SUNDRY NOTICES AND REPORTS ON WELLS (DO NOT USE THIS FORM FOR PROPOSALS TO DRILL OR TO DEEPEN OR PLUG BACK TO A DIFFERENT RESERVOIR. USE "APPLICATION FOR PERMIT" (FORM C-101) FOR SUCH PROPOSALS.)		WELL API NO. 30-025-39366
1. Type of Well: Oil Well ☒ Gas Well ☐ Other ☐		5. Indicate Type of Lease STATE ☒ FEE ☐
2. Name of Operator CML Exploration, LLC		6. State Oil & Gas Lease No. 303999
3. Address of Operator P.O. Box 890, Snyder, Texas 79550		7. Lease Name or Unit Agreement Name Paddy 19 State
4. Well Location Unit Letter C_: 900 feet from the North line and 1650 feet from the West line Section 19 Township 17S Range 33E NMPM Lea County		8. Well Number 4
11. Elevation (Show whether DR, RKB, RT, GR, etc.) 4116' GR		9. OGRID Number 256512
		10. Pool name or Wildcat Wildcat G-03 S173318N; Yeso

Propose plug and abandon procedures as follows beginning April 2024:

Lease & Well No.: **Paddy"19" State No. 4**

Operator: CML EXPLORATION, LLC P.O. Box 890 Snyder, TX 79550	OGRID: 256512
	Action Number: 315174
	Action Type: [C-103] NOI Plug & Abandon (C-103F)

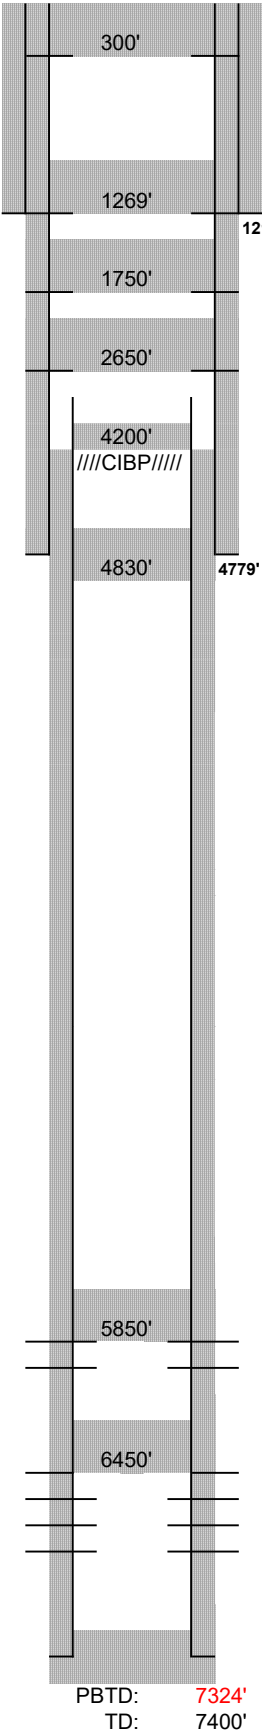
Plug # 1 - Spot 40 sx "C" cement 6,450 - 6,100' (Blinberry perfs), WOC & Tag

Plug # 2 - Spot 40 sx "C" cement 5,850 - 5,500' (Paddock squeezed holes), WOC & Tag

Plug # 3 - Spot 40 sx "C" cement 4,830 - 4,480' (8 5/8" casing shoe), WOC & Tag

Plug # 4 - CIBP @ 4,200', Spot 25 sx "C" cement (Grayburg/SX) Spot 15 sx cmt 4488' - 4388' - T SA

Cut & Pull 3,600' of 5 1/2" casing Spot 25 sx cmt 3650' - 3550' - T Casing cut - WOC & tag - Run CBL

Plug # 5 - Perf & sqz 60 sx "C" cement 2,650 - 2,450' (base of SX) Spot 27 sx cmt @ 3378' - 3278' - T Queen

Plug # 6 - Perf & sqz 60 sx "C" cement 1,750 - 1,550' Rustler - WOC & Tag Cement 2410' - 2310' - T Yates

Plug # 7 - Perf & sqz 60 sx "C" cement 1,269 - 1,100' (13 3/8" casing shoe) B Salt

Plug # 8 - Perf & sqz, Circ to surface 120 sx "C" cement 300 - 3'

Created By	Condition	Condition Date
gcordero	A CBL must be run on 8 5/8" casing and submitted to OCD via OCD Permitting.	3/14/2024
